WEST RIDGE MINE
007/041

ALTERNATE HIGHWALL RECLAMATION PLAN
RESPONSE TO T.A.
DIVISION ORDER 00A-7

Re: Response to Highwall TA, Division Order 00A-7, West Ridge Mine, C/007/0041

West Ridge Mine
Response to Division Order
C/007/041-D000A-7
Technical Analysis

Plate 1

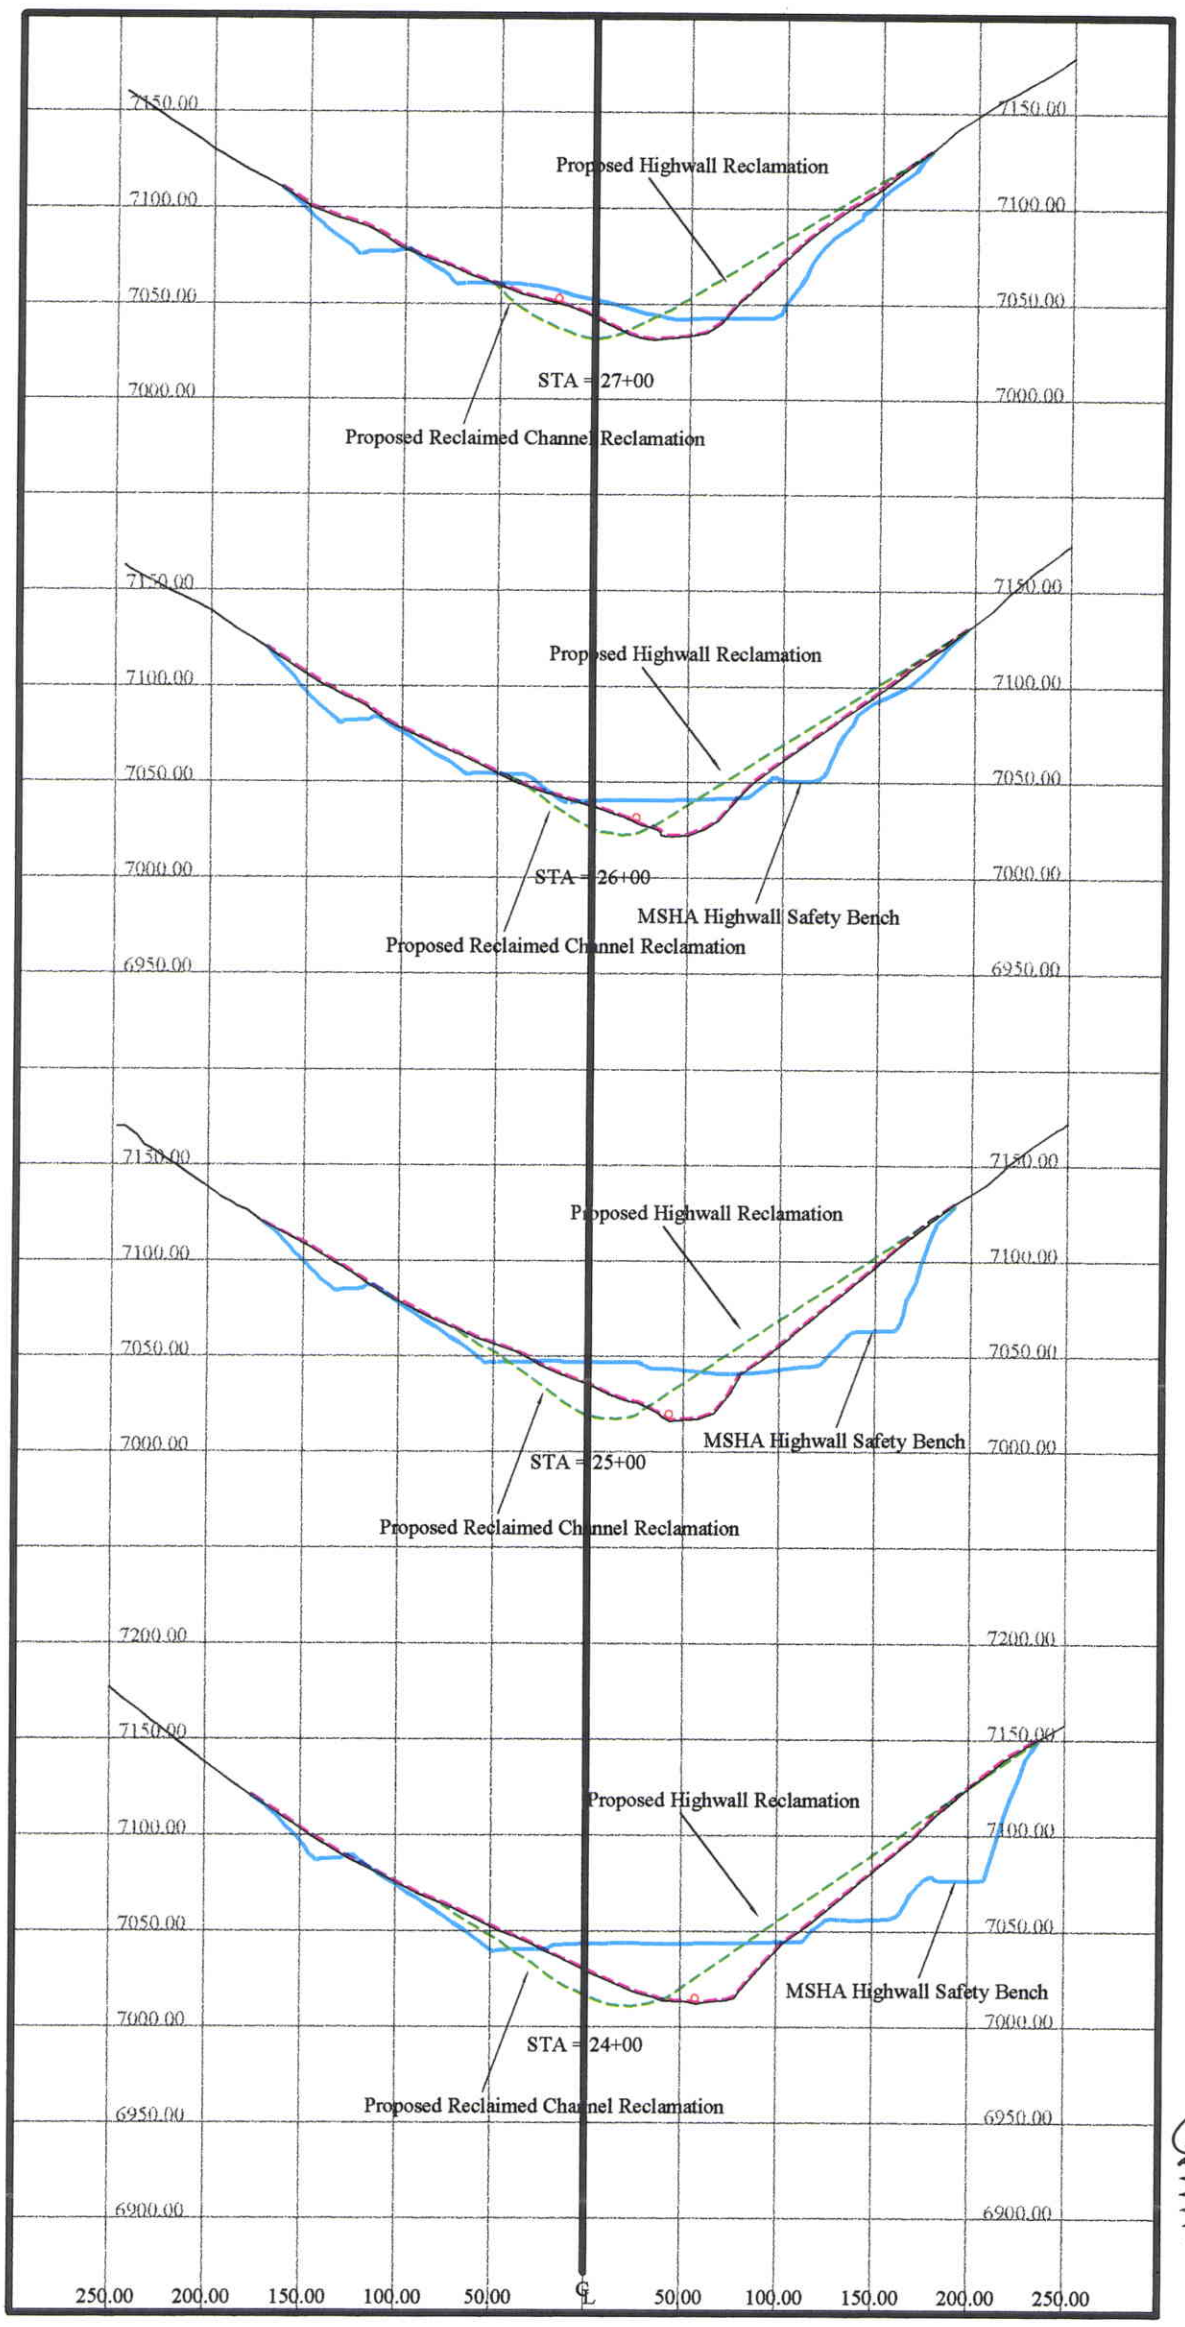
Provide the above-cited corrections so the Maps 5-6B, and Maps 1 and 2 from Appendix 5-10 consistently reflect the same information;

Maps have been corrected and reflect latest As-Constructed information.

Plate 2

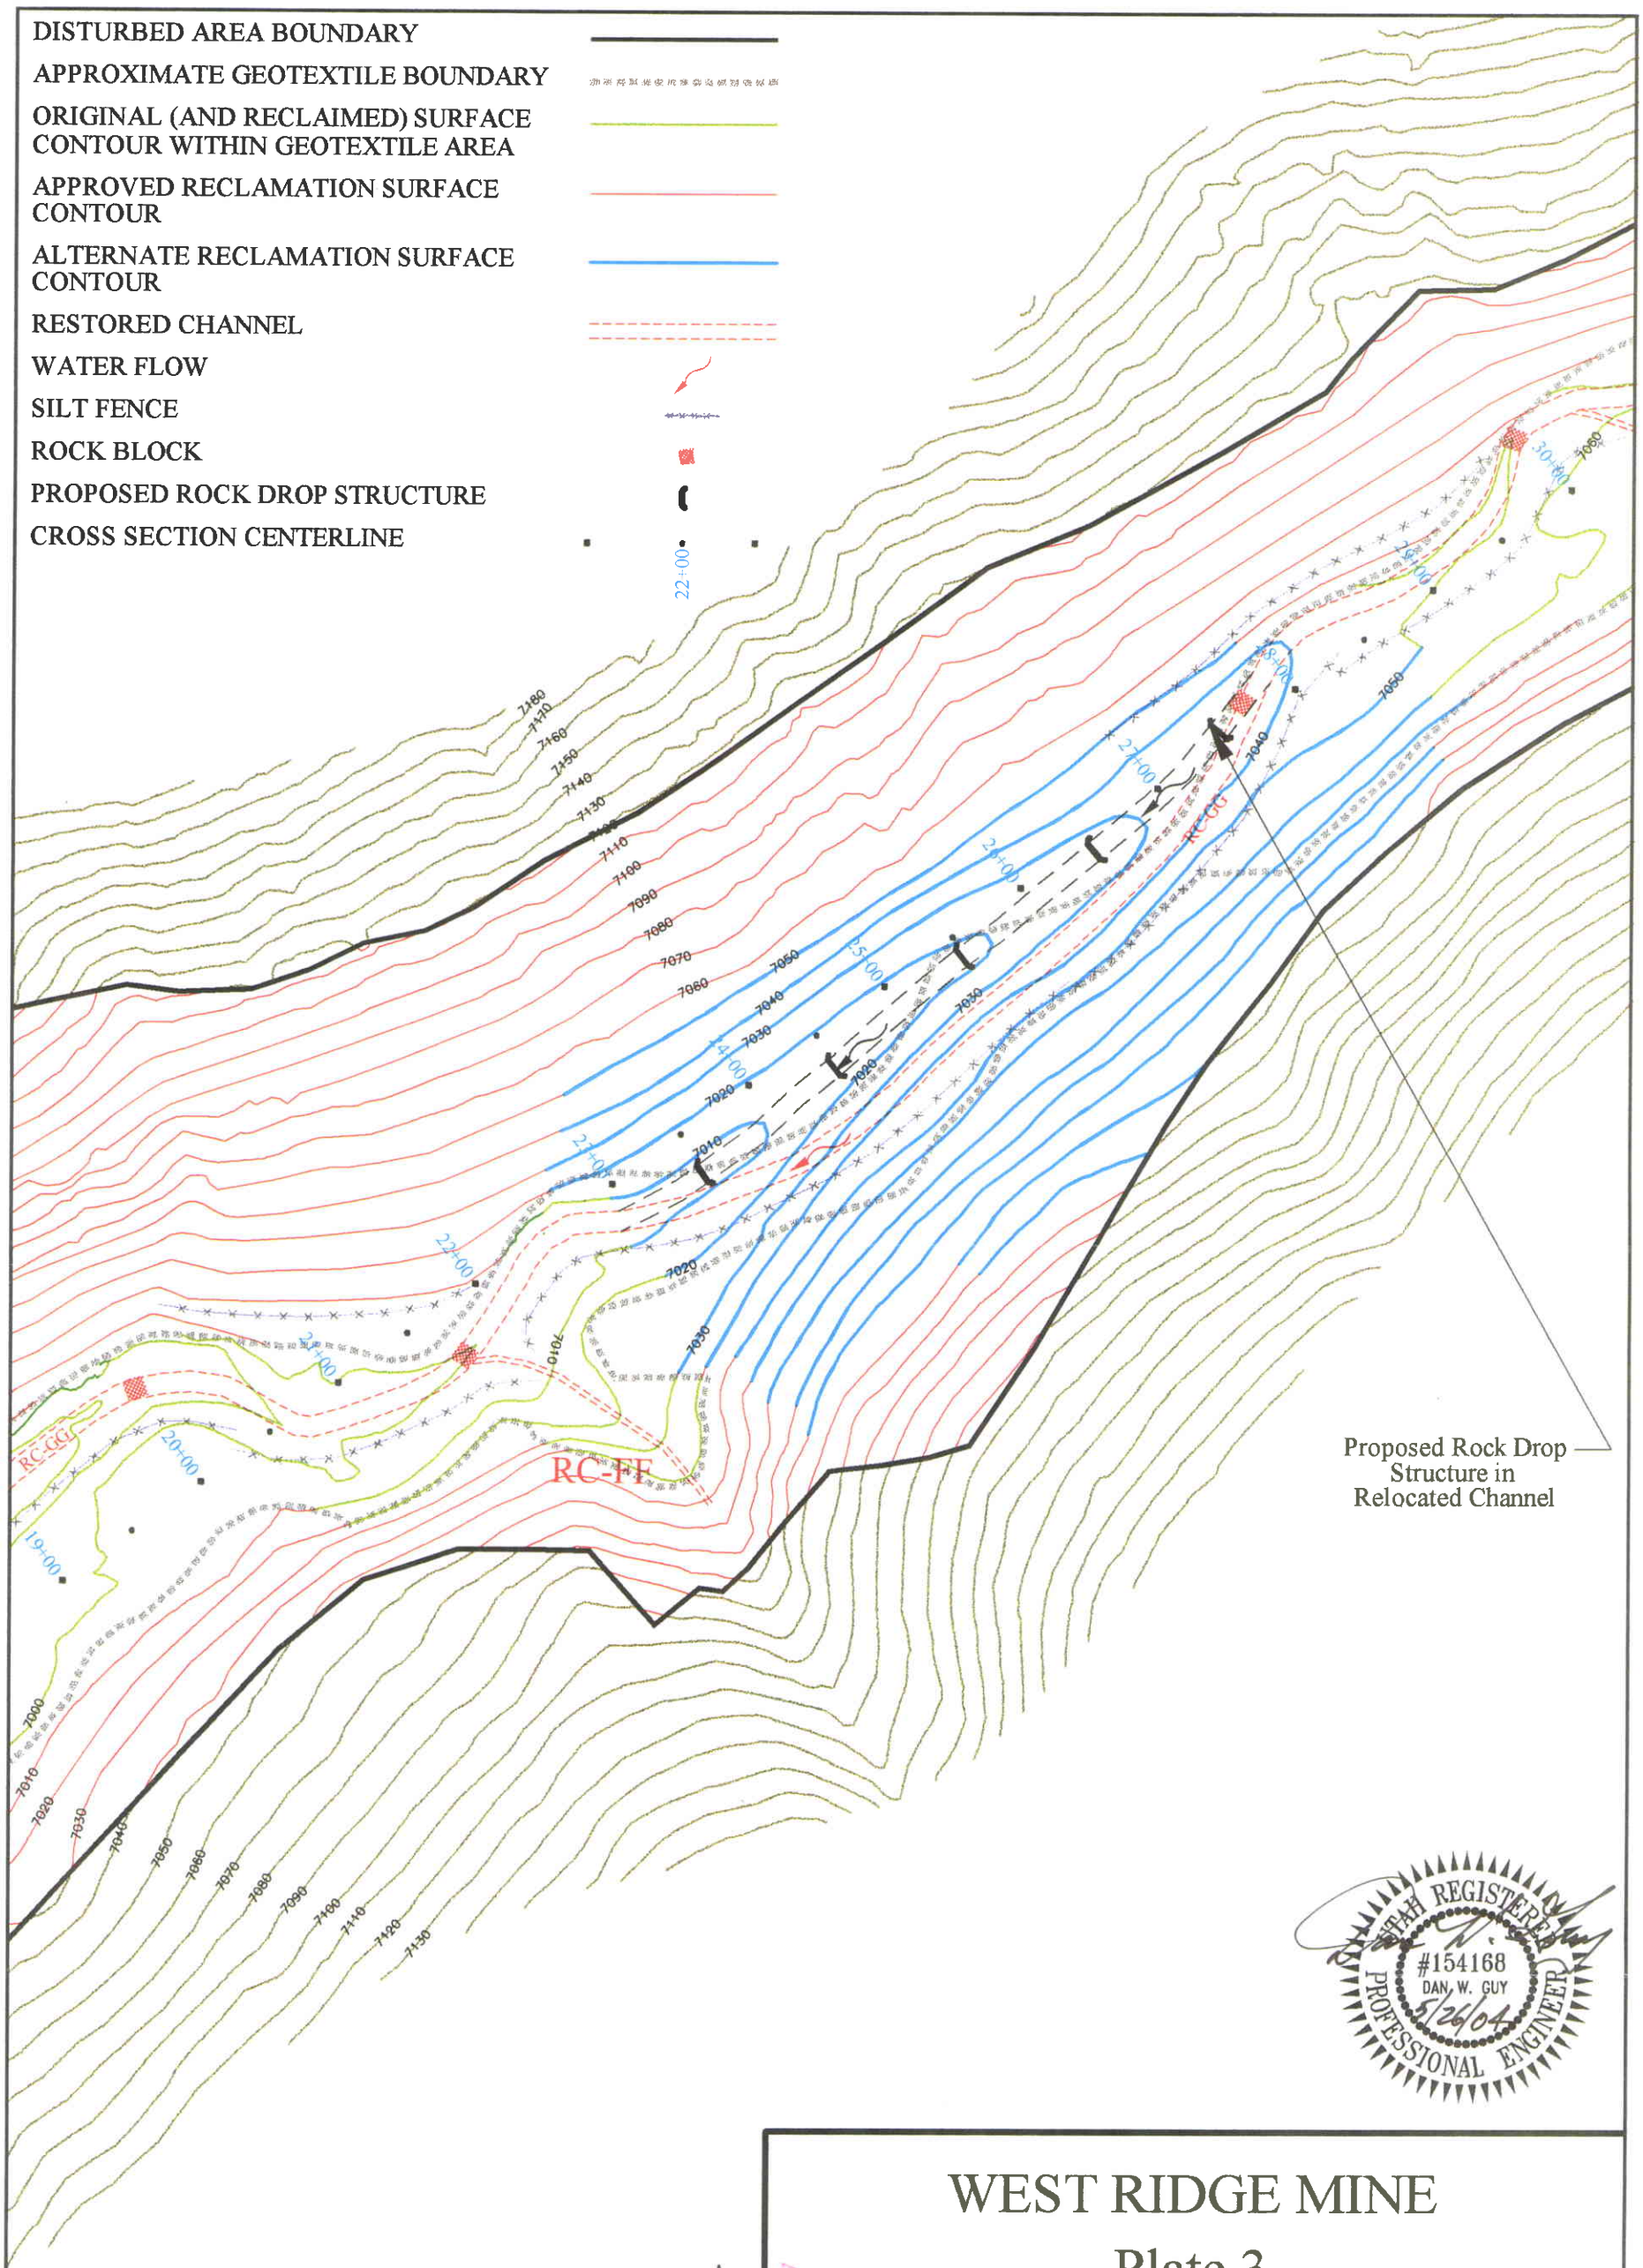
Per the above-cited discussion, provide maps, cross sections, calculations, and designs for the proposed reclamation channel;

Maps, cross sections, calculations and designs for the proposed reclamation channel are provided in the revised Appendix 5-9.
